Flood Risk Assessment & SuDS Drainage Strategy

Land at Status Park, Nobel Drive, Hillingdon

JOB NUMBER: 4401/2023
DOCUMENT REF: FRA&SuDS Status Park
REVISIONS: D – Response to LLFA

2.1 This section summarises the response to the LLFA comments as outlined in the comments letter for application Ref. 74423/APP/2024/1908, dated 24th December 2024. The comments are presented below in grey, with EAS responses in blue.

Appendix I – SuDS Surface Water Drainage Strategy Drawing

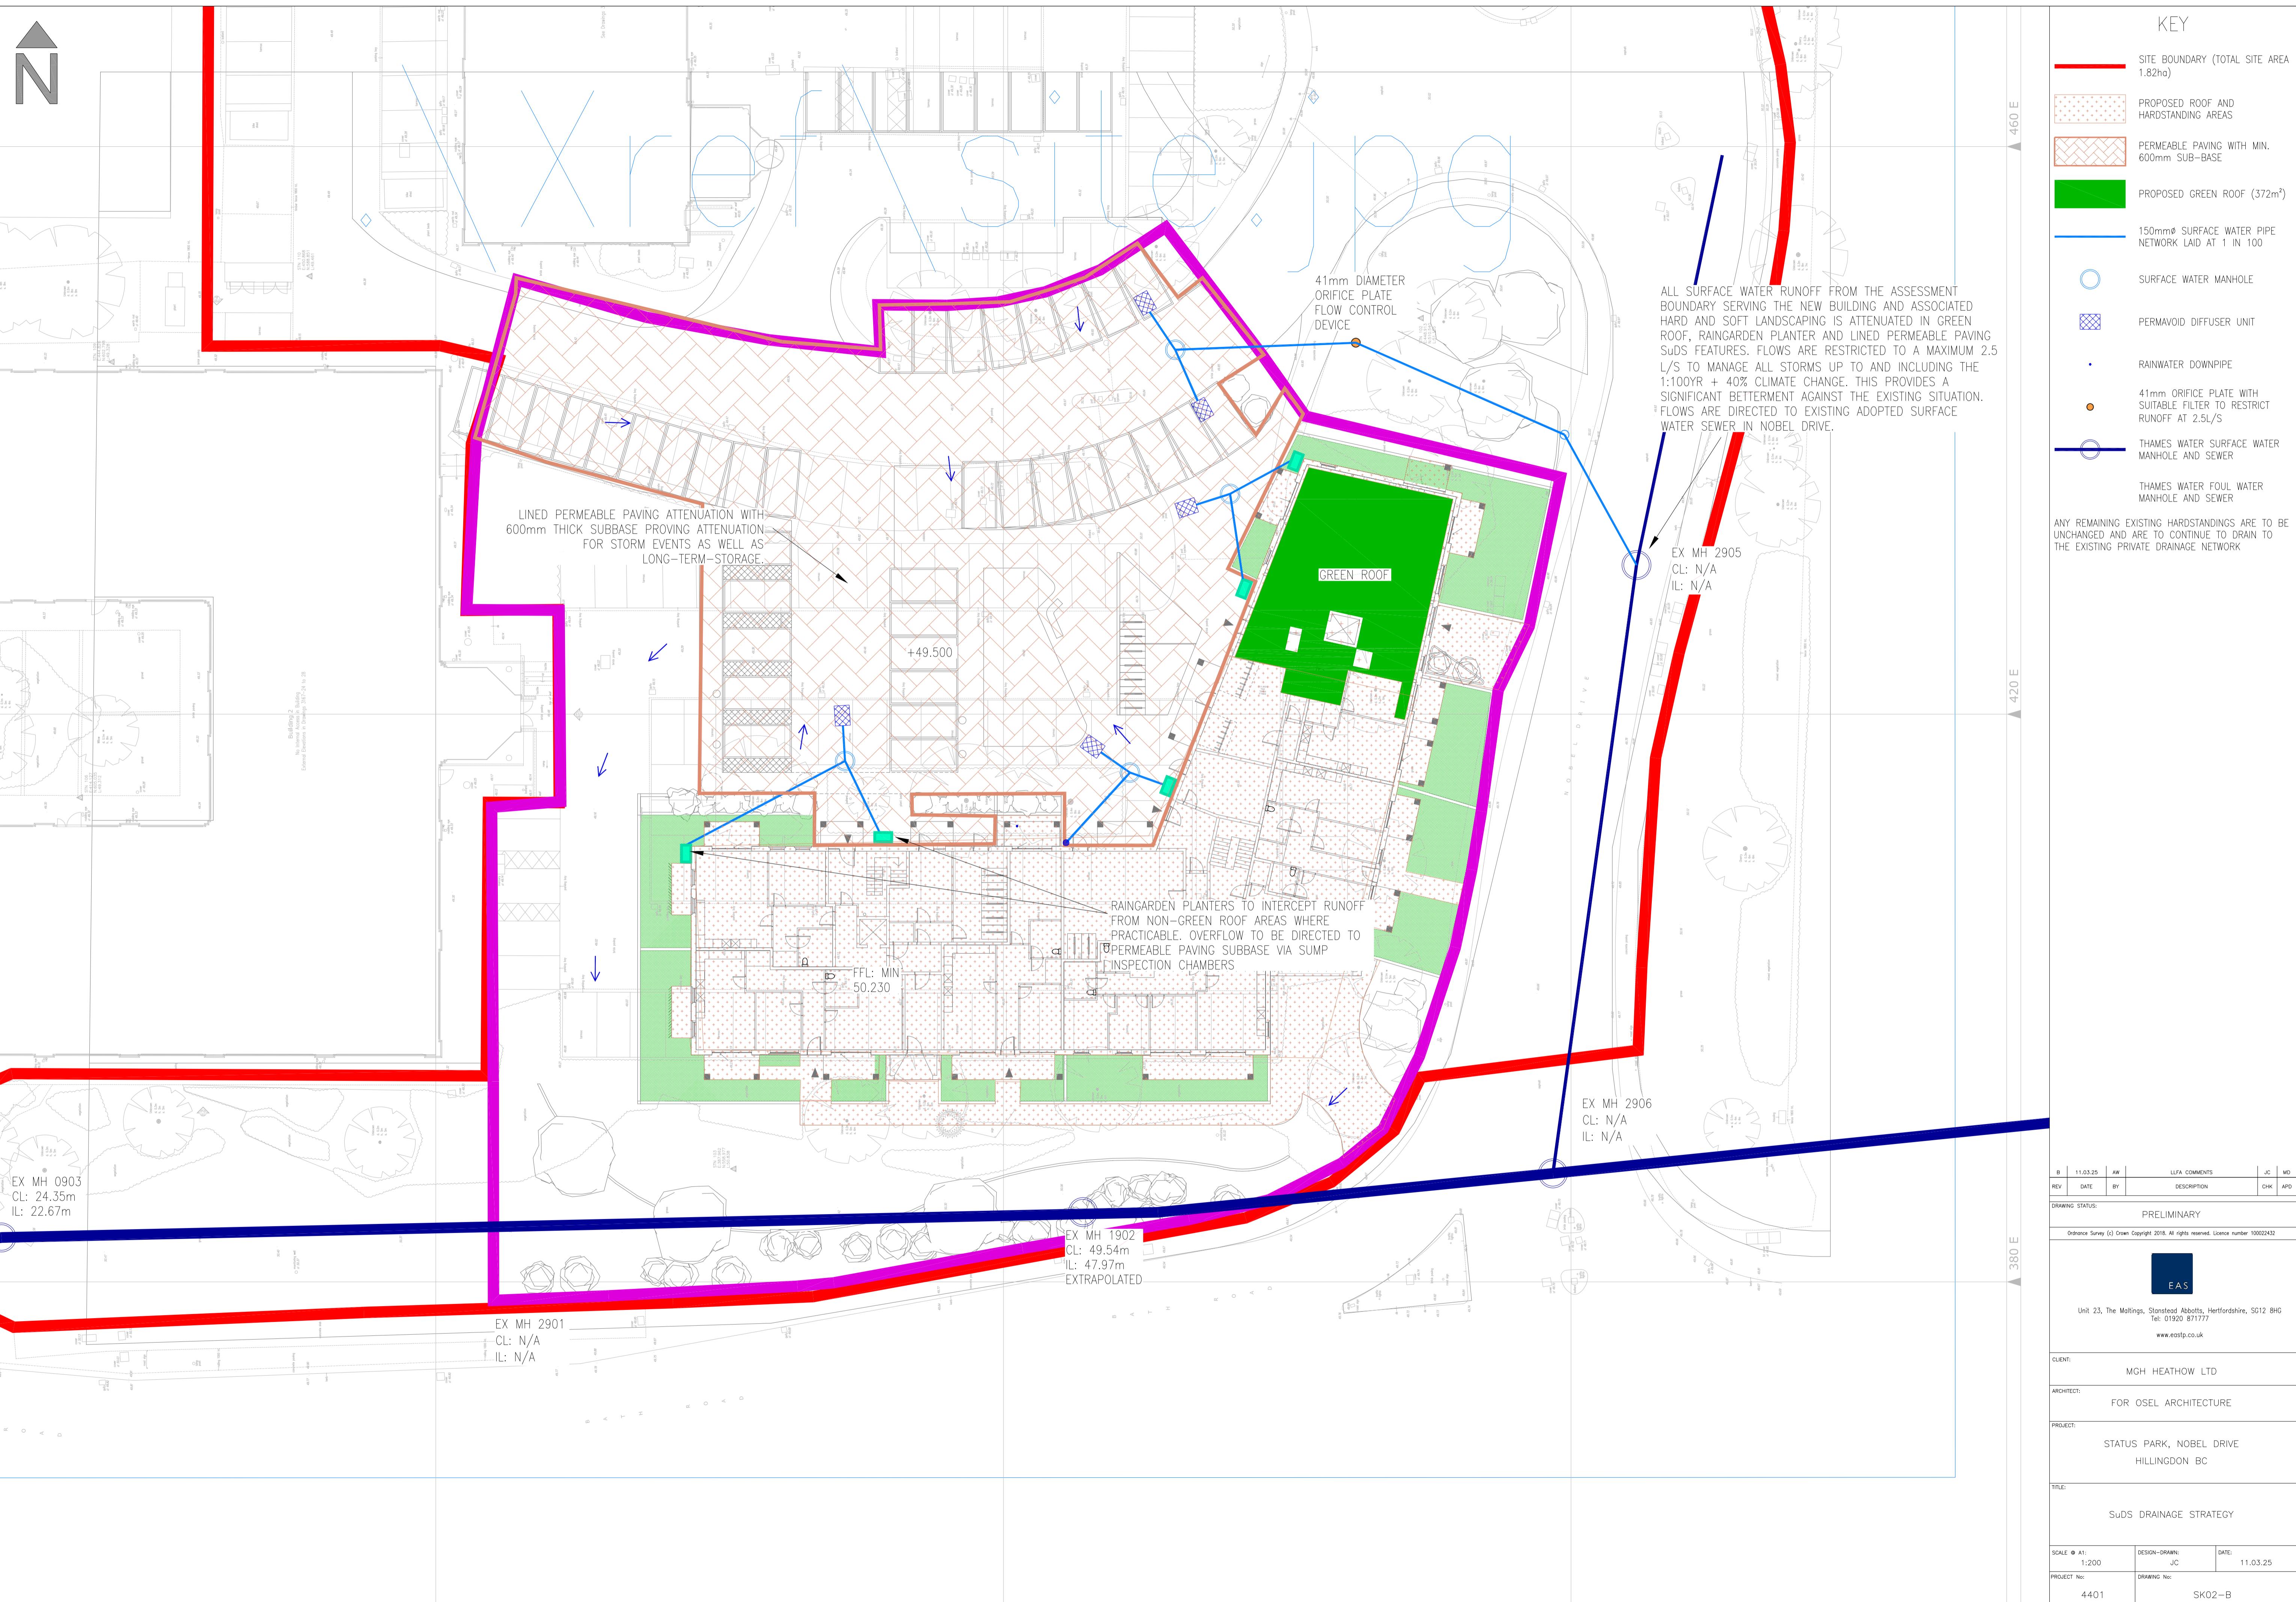
Shows where on site exceedance flows are expected to collect and shows how flows will be directed away from buildings.

- 2.7 Exceedance flow arrows, shown in blue, have been added to the SuDS Layout. As noted in Section 6.37, during an exceedance event, the permeable paving will surcharge and water will pool within this area of the site until it slowly recedes back into the proposed drainage network. Some surface water might disperse into the grassed area in the west of the site.
